# Access Compliance Report

## Public Rights-of-Way

### (Curb Ramps)

Intersection ID: 11796	Main Street: N_PINE_ST	Cross Street: W_6TH_ST	Location: E
ADA ID: A1A6A90A02D9	Ramp Type: PerpDiag	Initial Pass/Fail: Fail	Overall Compliance: No
Severity Score: 37.5			
Codes/Mitigation Info/Possible Solution		Field Measurements/Component Compliance

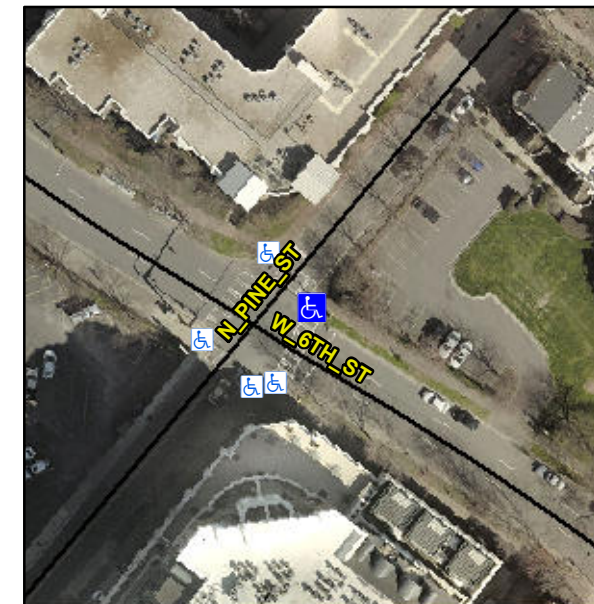
**Not Found, R304.2.2, R304.5.3**

Compliance	Description	Data	Compliance	Description	Data
N/A	Ramp Length (in)	50.0	No	Ramp Slope (%)	15.1
Yes	Ramp Width (in)	78.0	No	Ramp XSlope (%)	6.6
N/A	Flare Type LT	N/A	N/A	Flare Type RT	N/A
N/A	Flare Slope LT (%)	N/A	N/A	Flare Slope RT (%)	N/A
N/A	Flare Traversable LT?	N/A	N/A	Flare Traversable RT?	N/A
N/A	Landing Length (in)	N/A	N/A	DWS Provided?	N/A
N/A	Landing Width (in)	N/A	N/A	DWS Contrast?	N/A
N/A	Landing Slope (%)	N/A	N/A	DWS Length (in)	N/A
N/A	Landing X Slope (%)	N/A	N/A	DWS Full Width?	N/A
N/A	Landing Curb? (Y/N)	N/A	N/A	DWS Offset (in)	N/A
N/A	Shared Landing?	N/A			
N/A	Gutter Ponding?	N/A	N/A	Gutter Slope (%)	N/A
N/A	Gutter Lip Ht (in)	N/A	N/A	Gutter X Slope (%)	N/A
N/A	Painted X Walk1?	Yes	N/A	Painted X Walk2?	Yes
	X Walk 1 Direction	To NW		X Walk 2 Direction	To SW
N/A	X Walk 1 Width (in)	117.0	N/A	X Walk 2 Width (in)	100.0
	X Walk 1 Slope (%)	1.7		X Walk 2 Slope (%)	6.0
	X Walk 1 X Slope (%)	3.8		X Walk 2 X Slope (%)	1.2

N/A	Ramp inside XWalk1?	Yes	N/A	Ramp inside XWalk2?	Yes
	Road Slope (%)	5.4	N/A	Clear Space?	N/A
	Road X Slope (%)	3.4	N/A	Clear Space to XWalk (in)	N/A
N/A	Any Obstructions?	N/A	N/A	Storm Grate/Utility Hazard?	N/A
	Obstruction Type			Storm Grate/Utility Type	
		N/A			N/A
		Yes		Surface Condition? (G/P)	Good

**Remove & Replace Curb Ramp With Two New Directional Ramps or Equivalent.**
